RE: Response to EPA's Feb. 23, 2017  
Request for Additional Information  
and Clarification

Safety-Kleen received the Request for Additional Information and Clarification for the Demonstration Run Report submitted on July 22, 2016. This is Safety-Kleen's response to the above noted letter. As we discussed on April 28, 2017, the responses to Items # 6, 7, 17, 18 and 19 will be submitted by May 19, 2017.

Sample ID : #8 V330 1100 *LITE JAC*  
 Injection On: 1/27/2016 1:27:23 PM  
 Method : C:\HPCHEM\2\METHODS\F124216A.M  
 Modified : 1/23/2016 10:05:03 AM  
 Sample File : C:\HPCHEM\2\DATA\20160127\015F1601.D

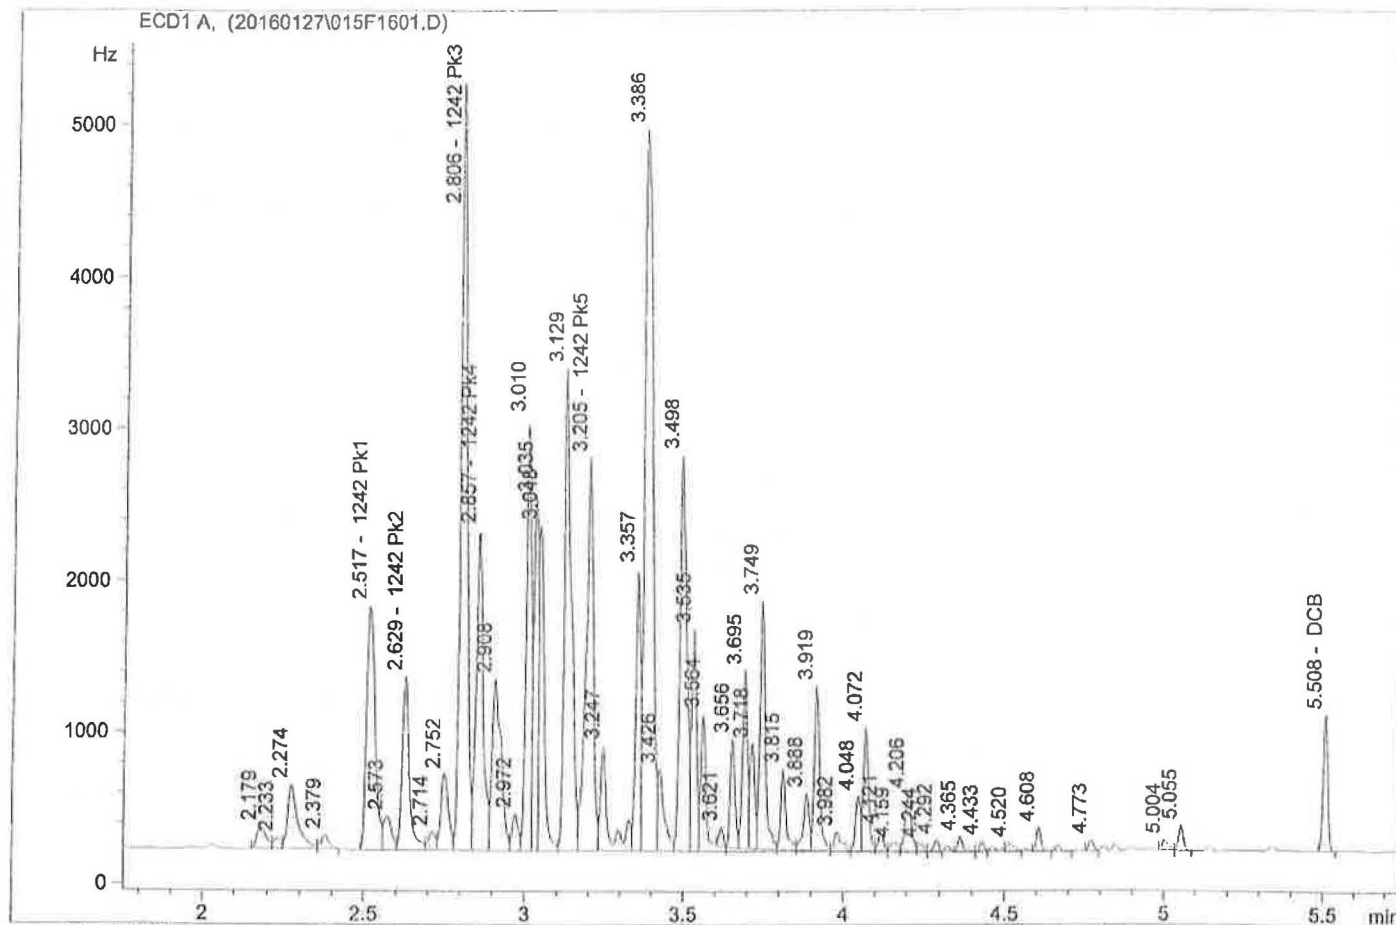
11. Provide the following information for Safety-Kleen sample of V-330 collected on January 27, 2016, at 1100.
  - a. Show quantification calculations as required on the PCB Calculation Worksheet and include a description of the dilutions.

- b. Please indicate if there was sample cleanup performed, what cleanup method was performed, and whether this was performed on all quality control samples.

- c. Explain the choice of the calibration peaks.

- d. Explain the use of four peaks instead of five for quantitation.

- e. Explain the reporting of the result on a dry weight basis.

*Attachment # 6 is the PCB Calculation Worksheet and chromatogram. This shows the peaks that were used and multiplied by the 5/4 in accordance with the SOP. The numbers that were added are calculated by Chemstation. If all the peaks were used, then we will use the number given without any other calculation.*

*Based in SKSOP 9202, we weight approximately 3 grams of sample and add 27 mL of hexane / acetone (90/10) into the vial. This yields a 1:10 sample dilution. Then, we transferred 1 ml of the 1:10 dilution into another vial containing 9 ml of hexane and it yields 1:100 total sample dilution.*

*Sample V330 (Lite Vac Oil) was cleaned by using 9 mL of hexane and 9 mL of sulfuric acid, shake and centrifuge. Then, the top layer was run on a 1 g/ 6 mL tubes of Strata FL-PR Florisil (170  $\mu$ m, 80A). Sample was collected on a GC vial and analyzed in the GC/ECD.*

*Based on SK SOP9202, the aroclors have pre-determined peaks (Appendix C) that we followed. The peaks are assessed for retention time and peak ratios. If there is interference or weathering, per SOP SK9202, it is permissible to quantitate using less than five peaks (which was the case for this chromatogram).*

*One of the five calibration peaks in this sample was much higher (peak#5) than the other four suggesting interference in the sample. The other four closely matching peaks were chosen for the calculation and multiplied by the ratio 5/4.*

*The result obtained on the  $\mu\text{g/ml}$  wet weight would be divided by the  $(1 - (\text{Water}\% / 100))$  to obtain  $\mu\text{g/g}$  dry wt. For this sample, the water is 0.1% water so the answer would be technically the same for wet and dry weight basis for this sample (16.8).*

### **Diagrams for the Location of all PCB Storage Areas**

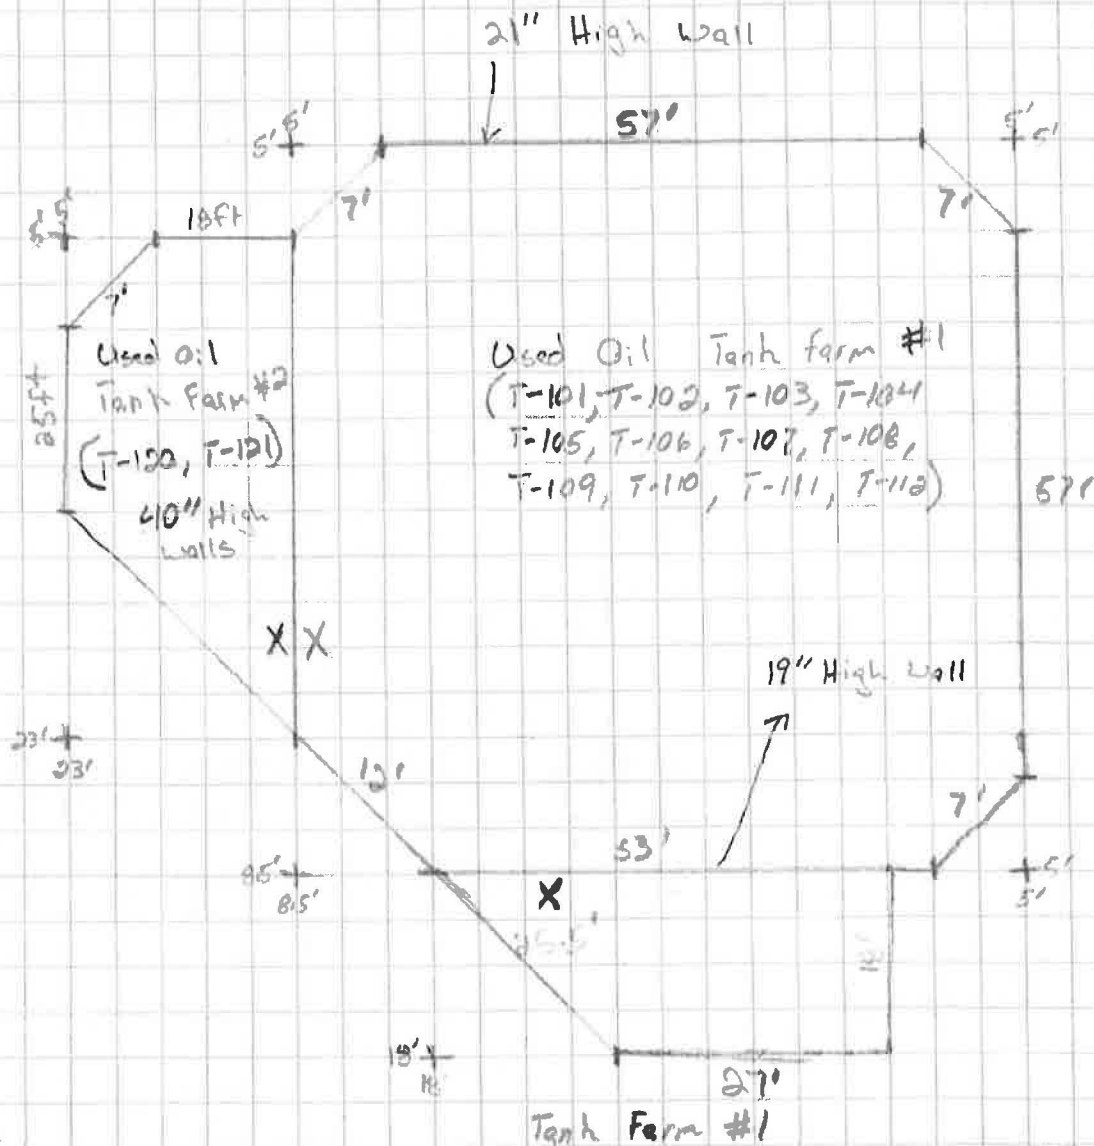
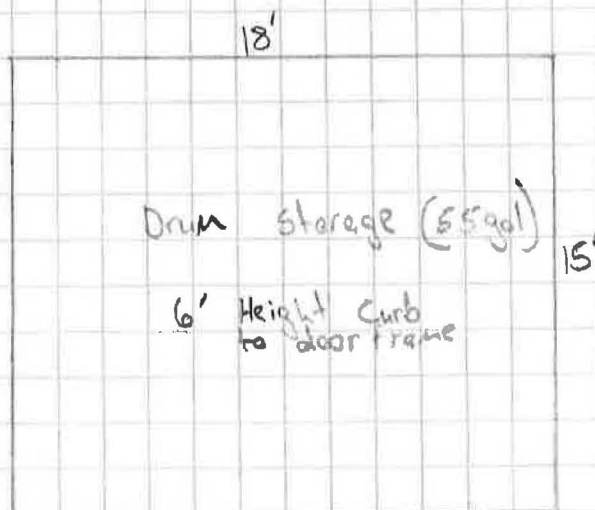
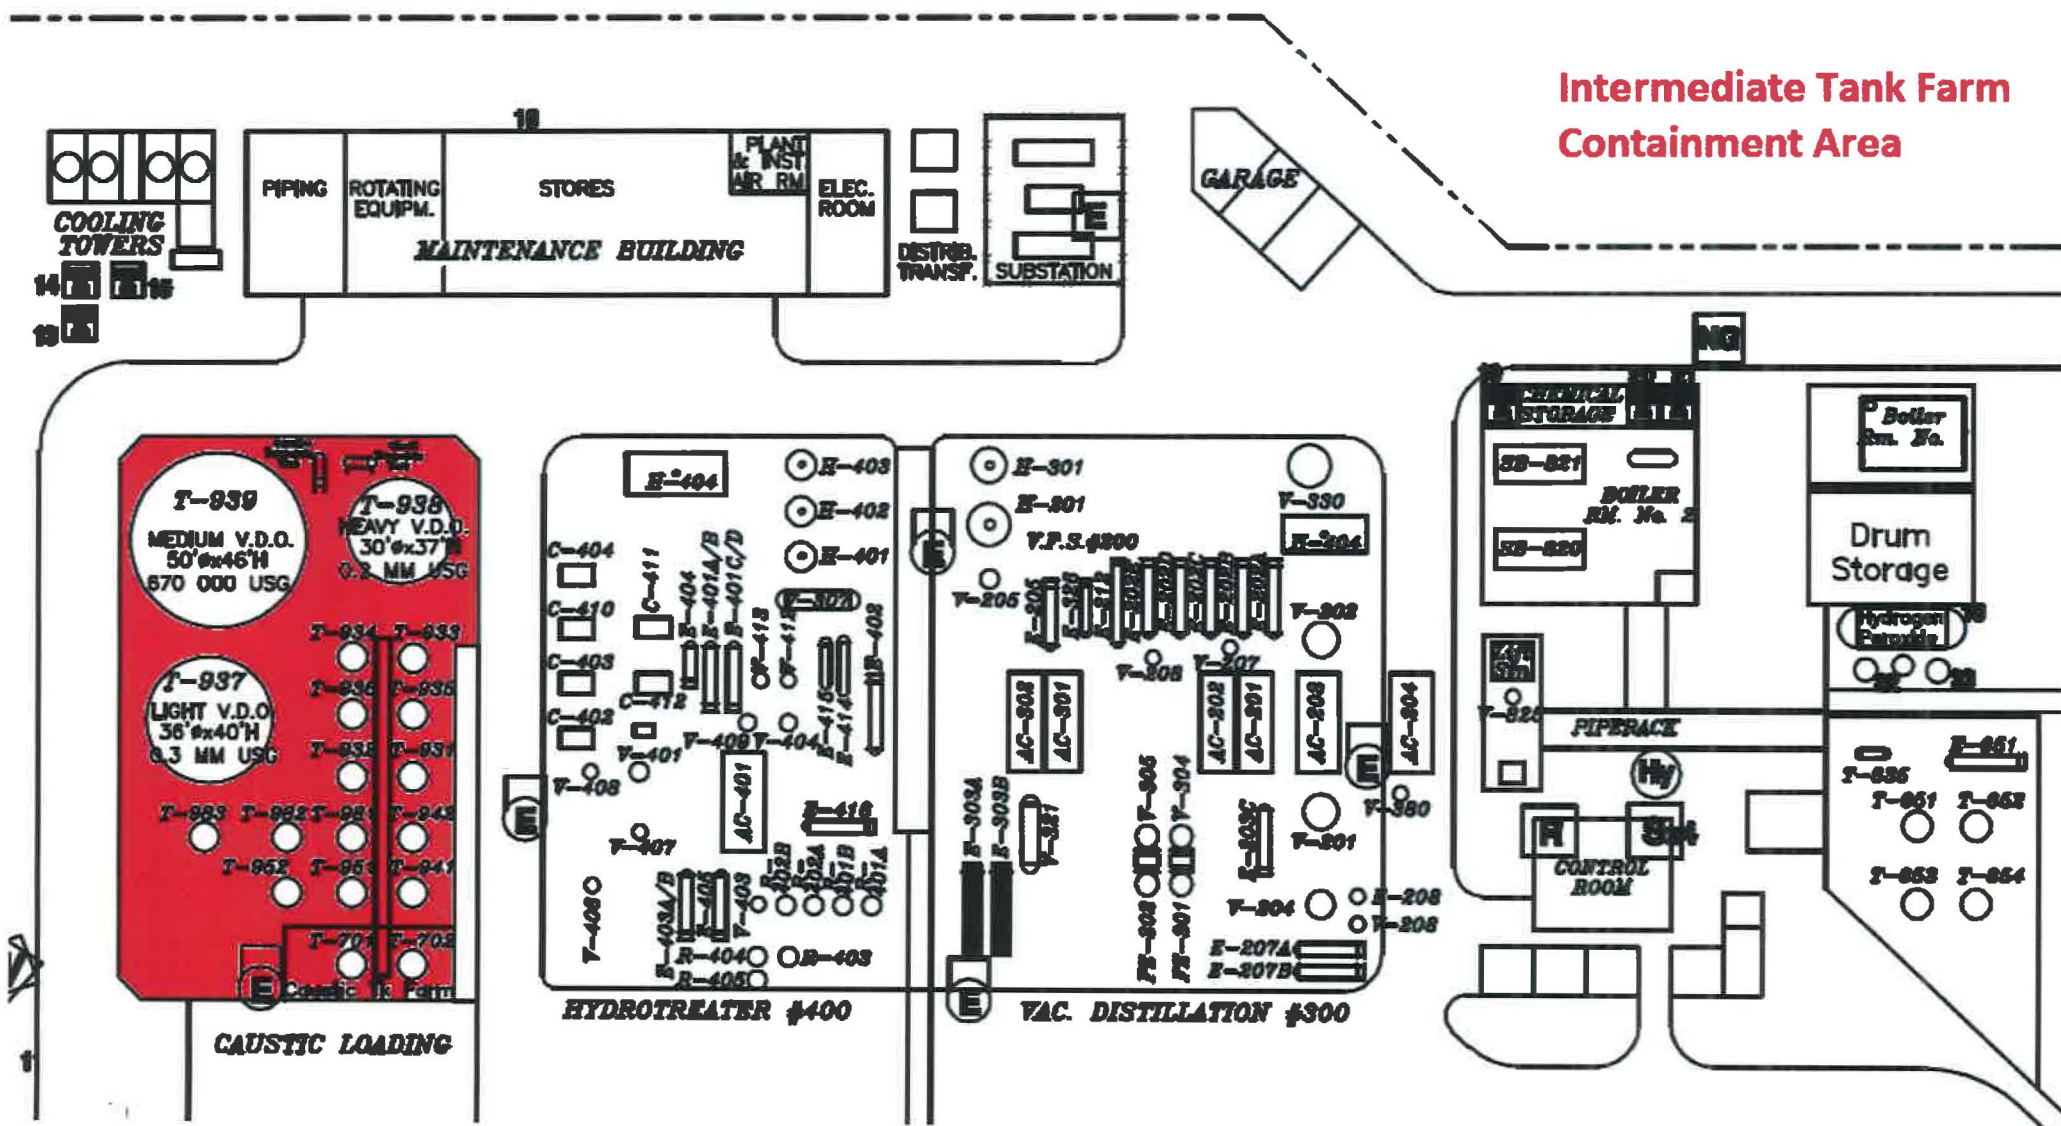
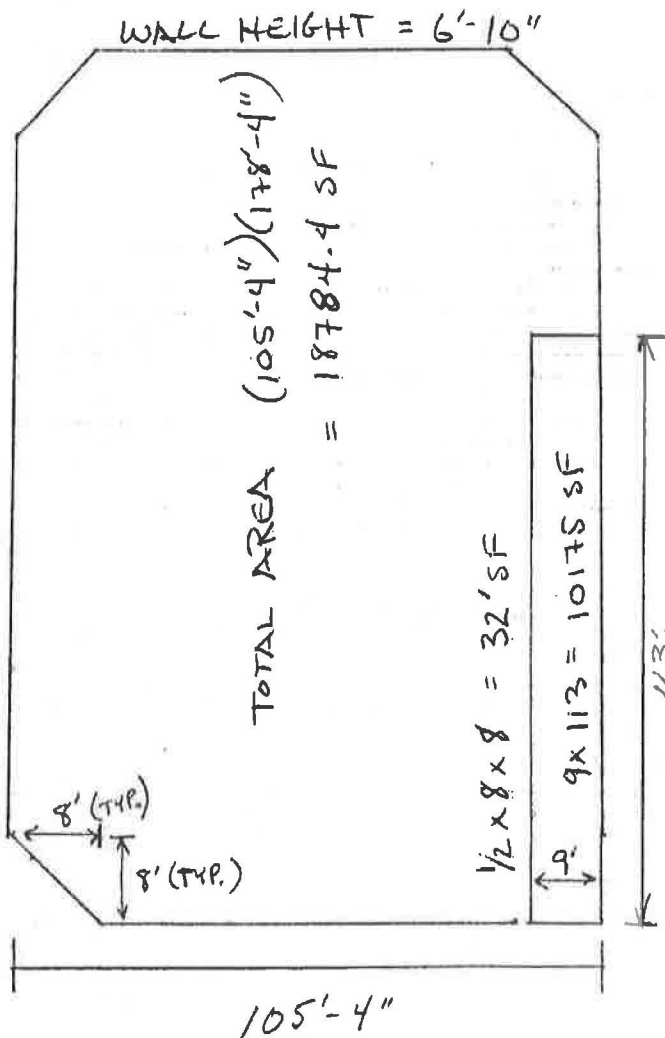
13. Provide a diagram depicting the location of all PCB storage areas (tanks and container storage area in Plant 1). This diagram must include dimensions of containment area including curb heights, floor slopes if applicable, locations of all tanks to be used for PCB storage, and locations of any other pertinent structures such as containment sumps, trenches, or drains.

*The diagram and calculations are included in Attachment #6. Also included is the Diagram for the VFS storage tanks in the Intermediate tank farm.*
